# Access Compliance Report

## Public Rights-of-Way

### (Curb Ramps)

Intersection ID: 29916	Main Street: NORTHRIDGE_DR	Cross Street: WILDBROOK_DR	Location: NW
ADA ID: 80362FE0489E	Ramp Type: PerpDiag	Initial Pass/Fail: Fail	Overall Compliance: No
		Severity Score: 25

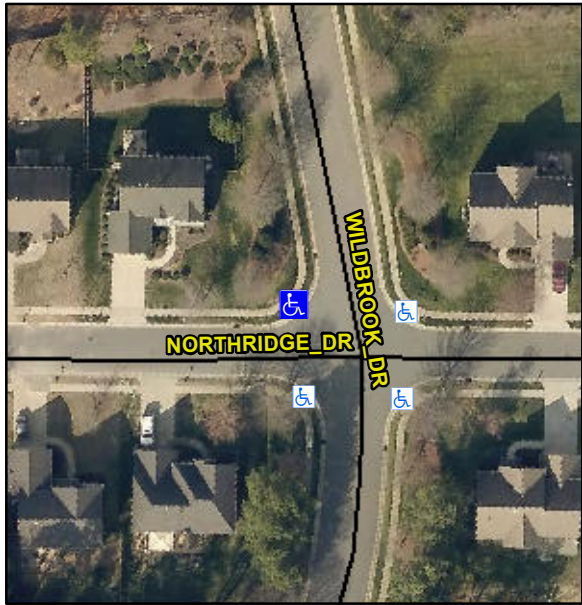
Codes/Mitigation Info/Possible Solution			Field Measurements/Component Compliance					
	Possible Solutions:		Compliance	Description	Data	Compliance	Description	Data
	<b>Remove &amp; Replace Curb Ramp With Two New Directional Ramps or Equivalent.</b>		N/A	Ramp Length (in)	49.0	No	Ramp Slope (%)	8.9
			Yes	Ramp Width (in)	50.0	No	Ramp XSlope (%)	6.4
			N/A	Flare Type LT	N/A	N/A	Flare Type RT	N/A
			N/A	Flare Slope LT (%)	N/A	N/A	Flare Slope RT (%)	N/A
			N/A	Flare Traversable LT?	N/A	N/A	Flare Traversable RT?	N/A
			N/A	Landing Length (in)	N/A	N/A	DWS Provided?	N/A
			N/A	Landing Width (in)	N/A	N/A	DWS Contrast?	N/A
			N/A	Landing Slope (%)	N/A	N/A	DWS Length (in)	N/A
			N/A	Landing X Slope (%)	N/A	N/A	DWS Full Width?	N/A
<p>Surveyor Notes:</p> <p>N/A</p>			N/A	Landing Curb? (Y/N)	N/A	N/A	DWS Offset (in)	N/A
			N/A	Shared Landing?	N/A			
			N/A	Gutter Ponding?	N/A	N/A	Gutter Slope (%)	N/A
			N/A	Gutter Lip Ht (in)	N/A	N/A	Gutter X Slope (%)	N/A

N/A	Painted X Walk1?	No	N/A	Painted X Walk2?	No
				X Walk 1 Direction	To S		X Walk 2 Direction	To E
			N/A	X Walk 1 Width (in)	N/A	N/A	X Walk 2 Width (in)	N/A
				X Walk 1 Slope (%)	4.7		X Walk 2 Slope (%)	0.4
				X Walk 1 X Slope (%)	1.1		X Walk 2 X Slope (%)	5.7
			N/A	Ramp inside XWalk1?	N/A	N/A	Ramp inside XWalk2?	N/A
<p>PROW/ADA:</p> <p>R304.2.2, R304.5.3</p>				Road Slope (%)	4.5	N/A	Clear Space?	N/A
				Road X Slope (%)	3.9	N/A	Clear Space to XWalk (in)	N/A
			N/A	Any Obstructions?	N/A	N/A	Storm Grate/Utility Hazard?	N/A
				Obstruction Type			Storm Grate/Utility Type	
					N/A			N/A
						Yes	Surface Condition? (G/P)	Good
Total Cost:		\$	3200.00
